## ARCHITECT'S ADDENDUM

### ADDENDUM NUMBER: 2

Date: **Tuesday, December 14, 2021**  
RE: NEA Board of Realtors Renovation  
912 Congress Cir, Jonesboro, AR  
Prepared by: Jamey McFadden, AIA  
To: Prospective Bidders  
Subject: Addendum 2 to the Construction Documents for NEA Board of Realtors Renovation

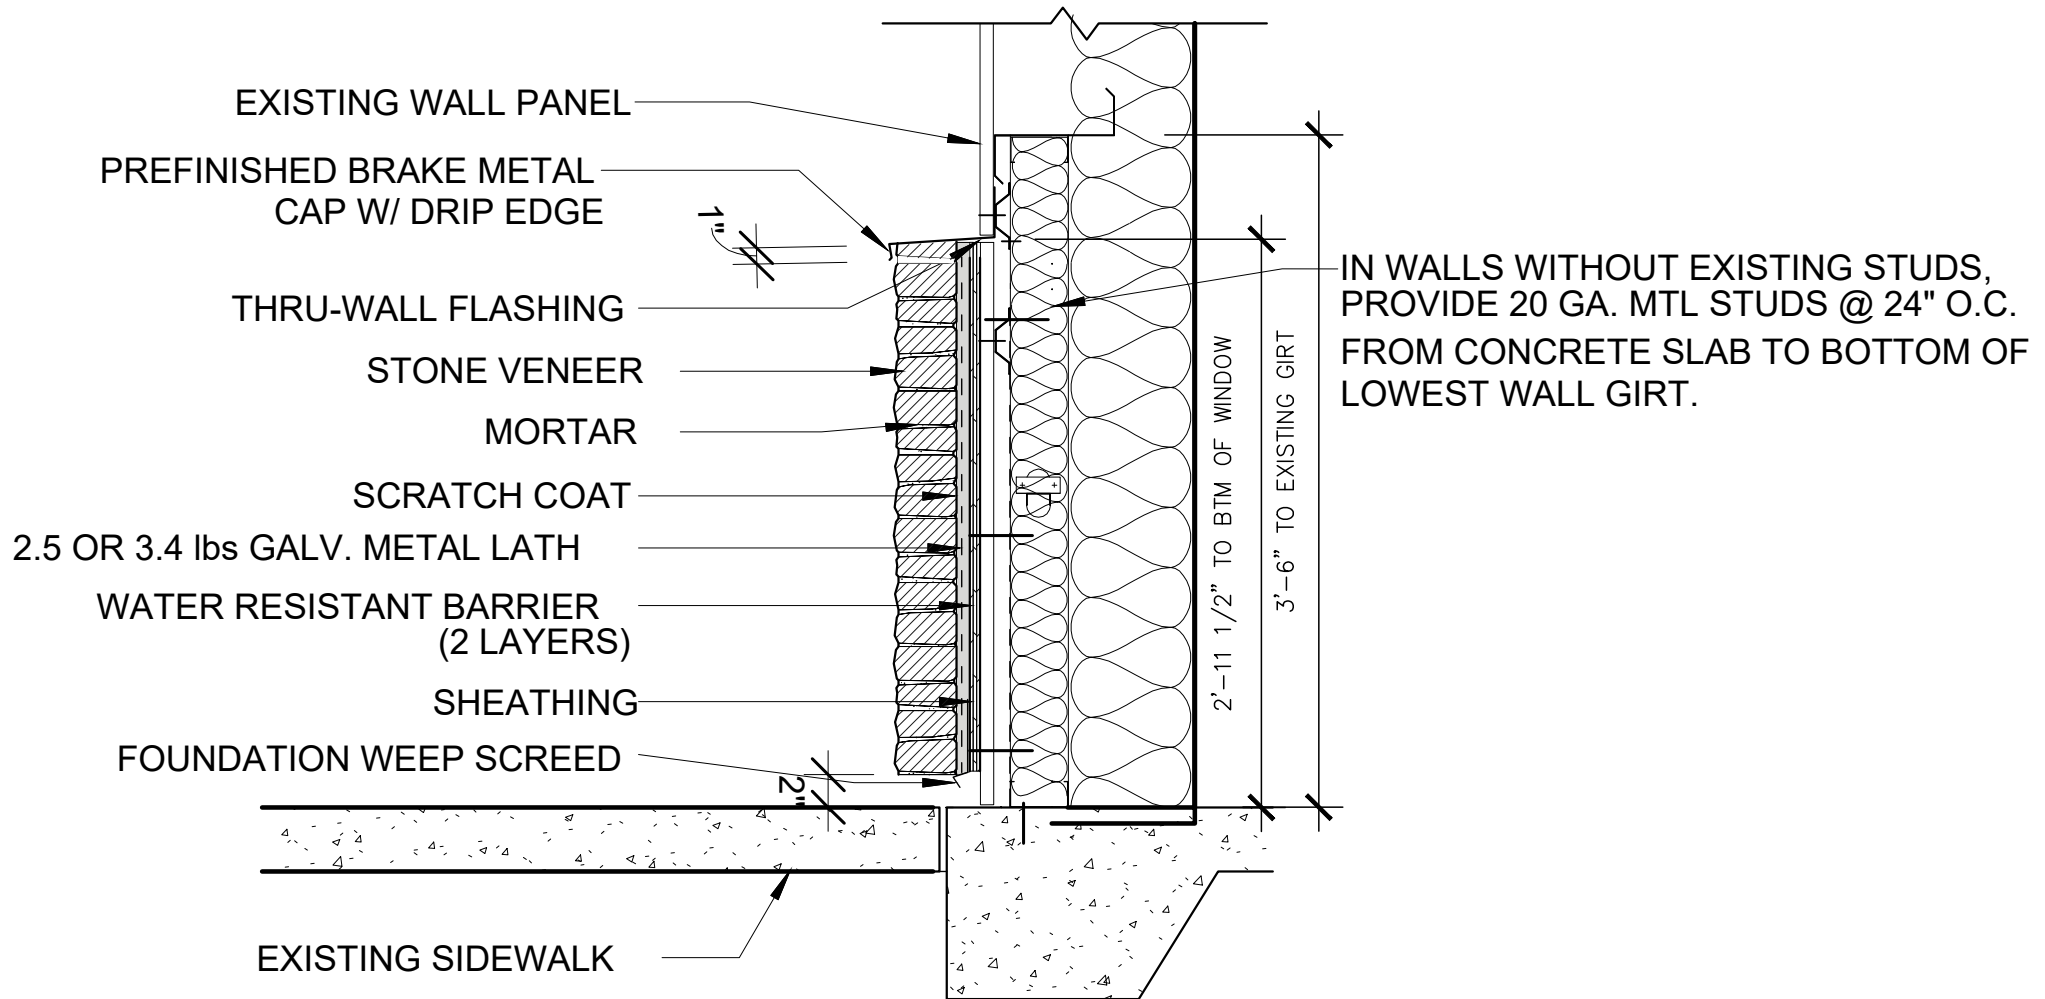
6. **Millwork:** Base cabinets and upper cabinets to have finished ends and matching edge banding, Wilsonart Slate Grey D91-60; cabinet doors – Wilsonart Lujo Collection, Daintree 8235; interior – White TFL. Solid Surface countertops (other than reception desk) - Durasein DM5015 Eventide. Provide Mockett DP3 series 3" Tab Pull hardware.

# 1 STONE VENEER WAINSCOT @ METAL PANEL

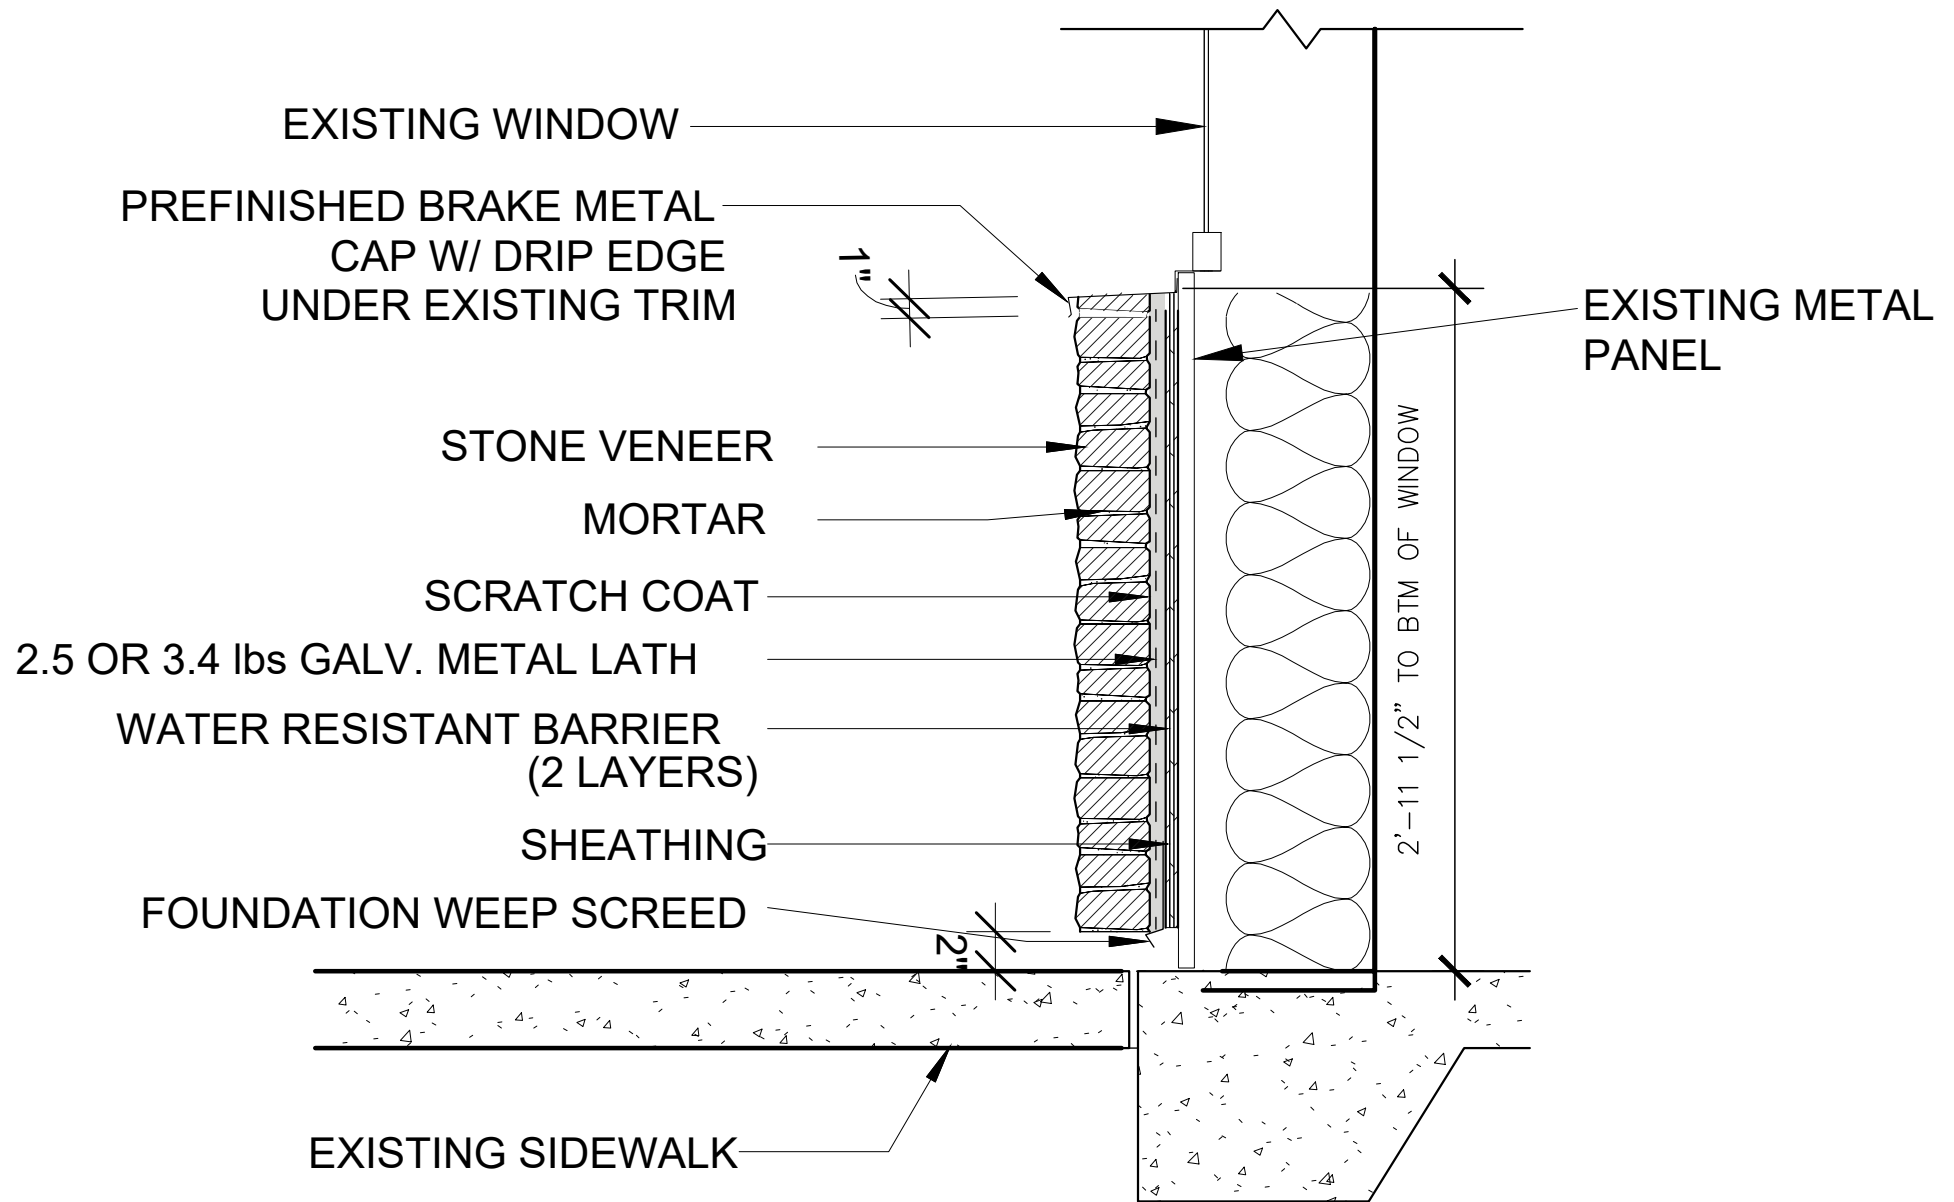
11. **Stone wainscot:** See attached details for clarification of installation. Provide studs in walls without existing studs for support.
12. **Stone wainscot:** eliminate stone veneer wainscot on the north exterior wall. Turn corners at east and west and extend 2' along north wall to avoid termination at corners. Metal panel infill on north wall to extend to match existing adjacent.

10 ENLARGED PLAN - TOILET 105  
1/2" = 1'-0"

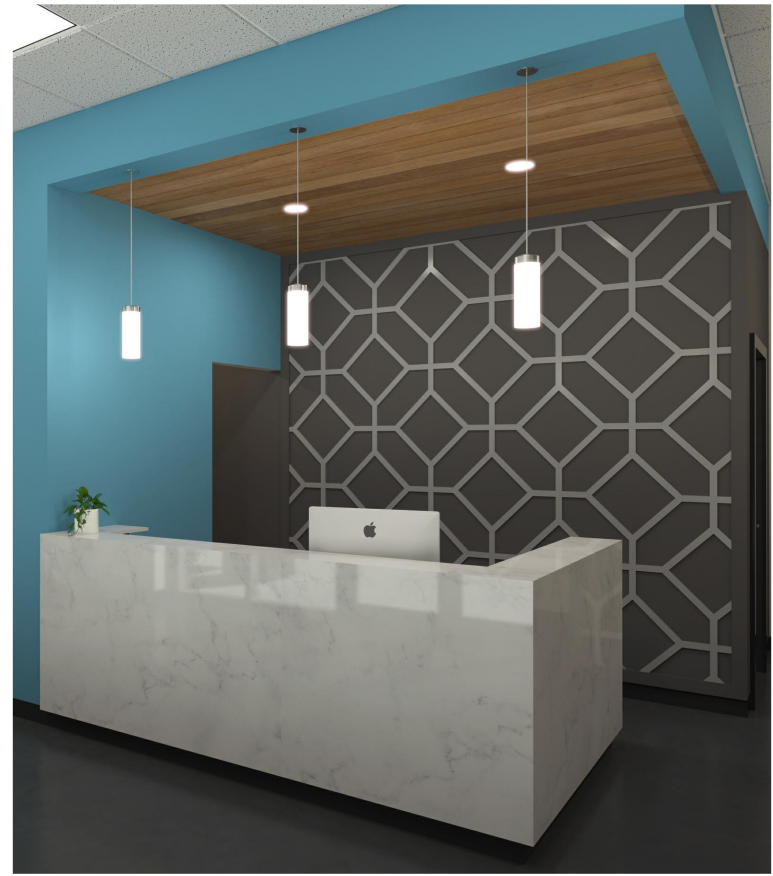
14. **Toilet 105:** to be A.D.A. compliant (see Enlarged Toilet Plan 10/A6).

7 RECEPTION DESK RENDERING  
NOT TO SCALE

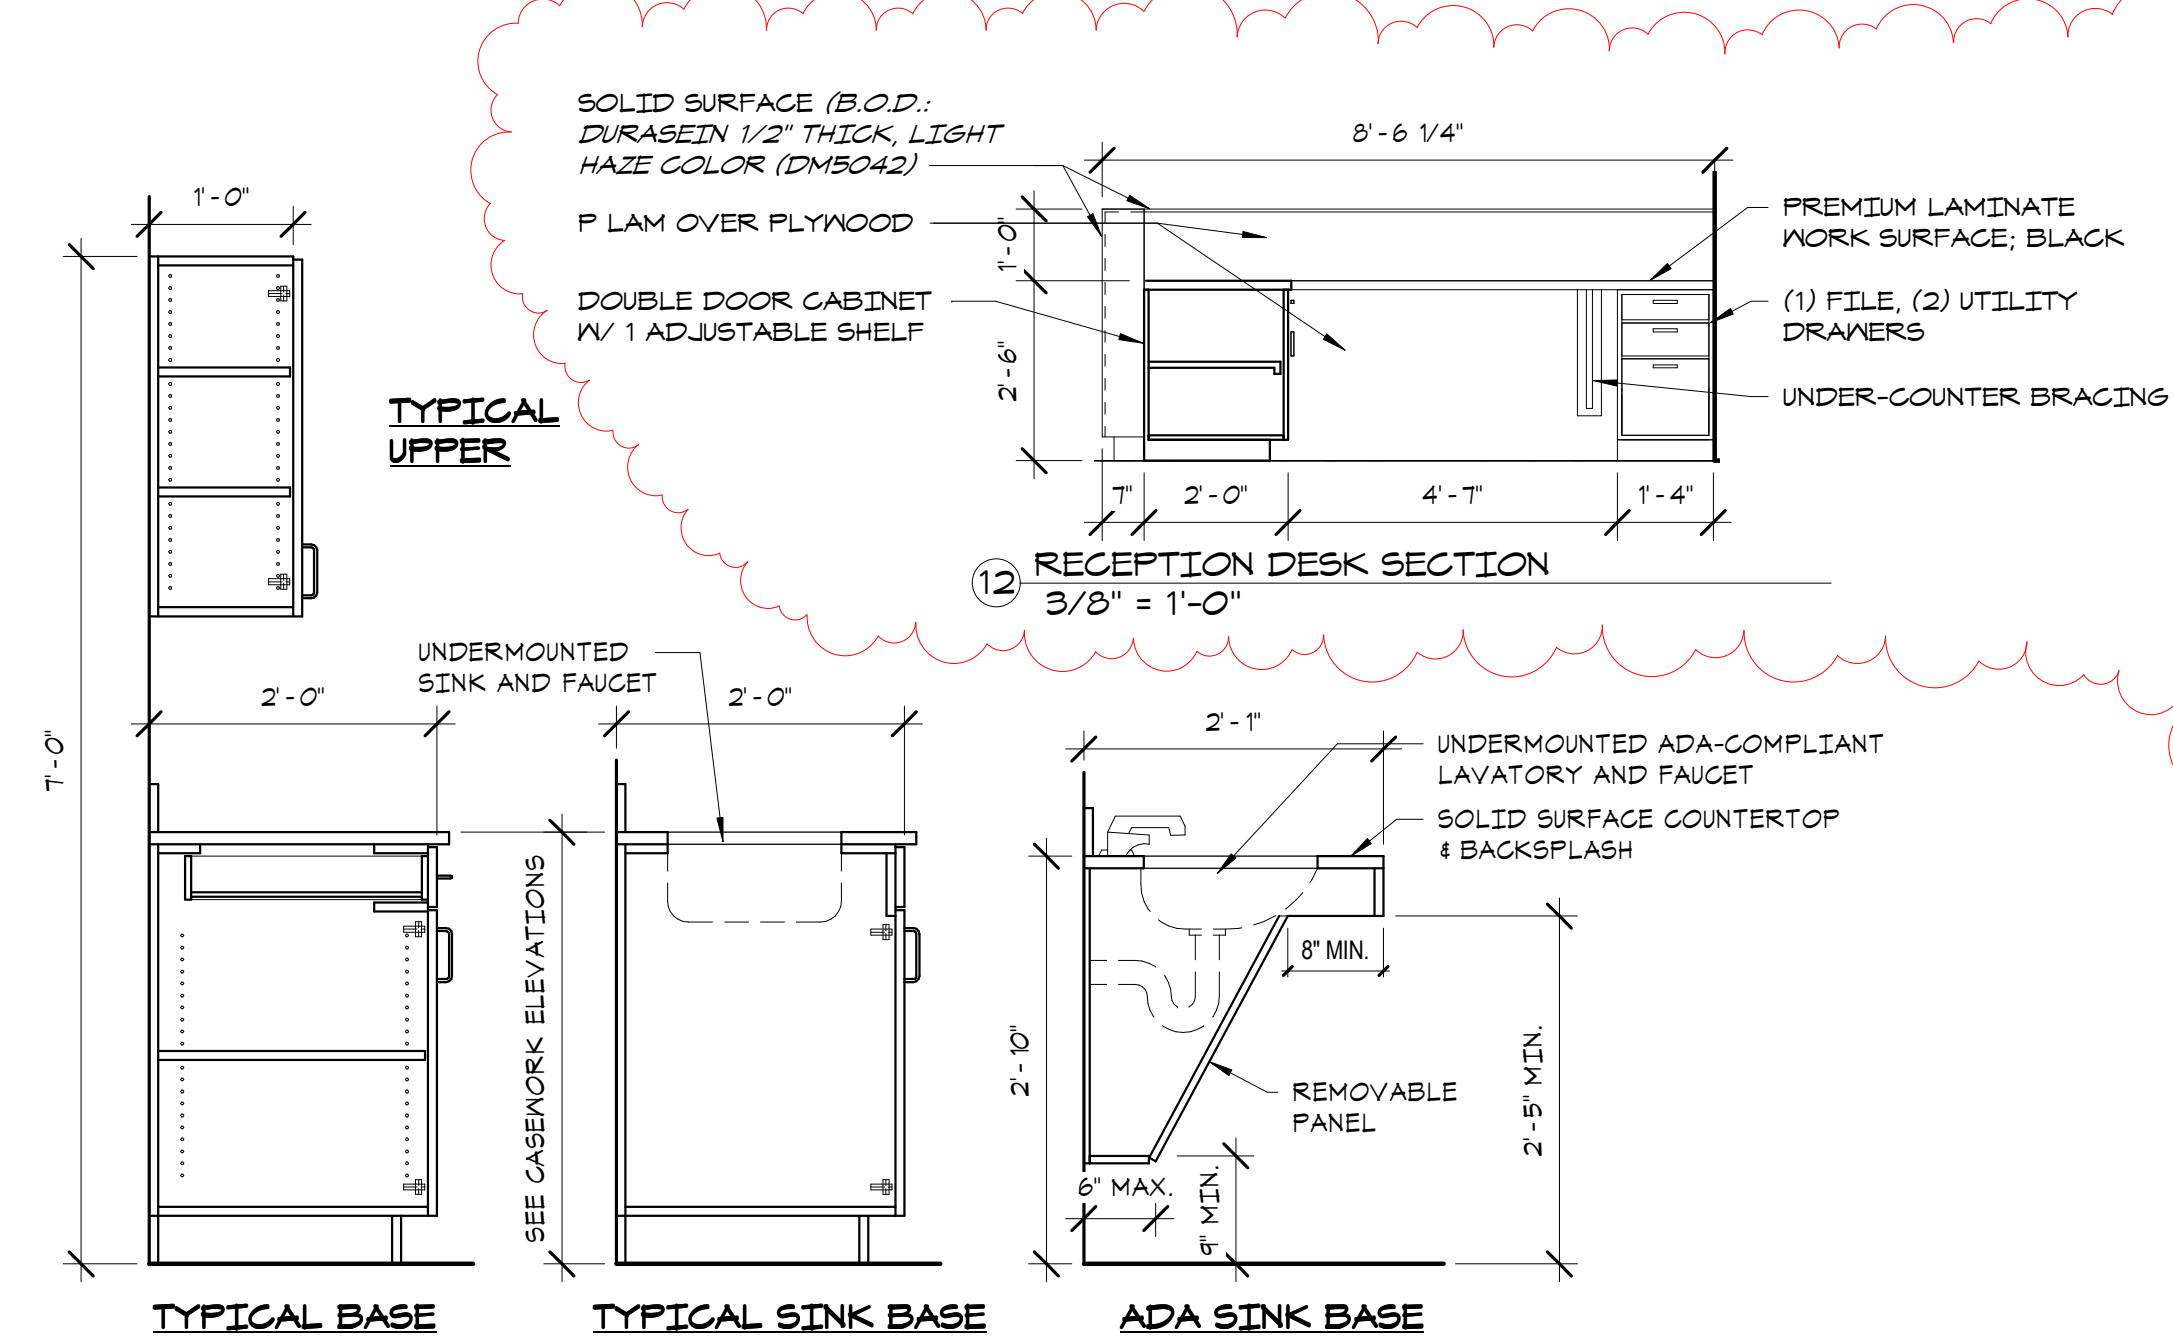
7. **Reception Desk:** Sheet A6 updated to show drawings of reception desk. Provide

double door base as shown. Provide file drawer and utility drawers as shown. Finished ends with matching edge banding Wilsonart Slate Grey D91-60.
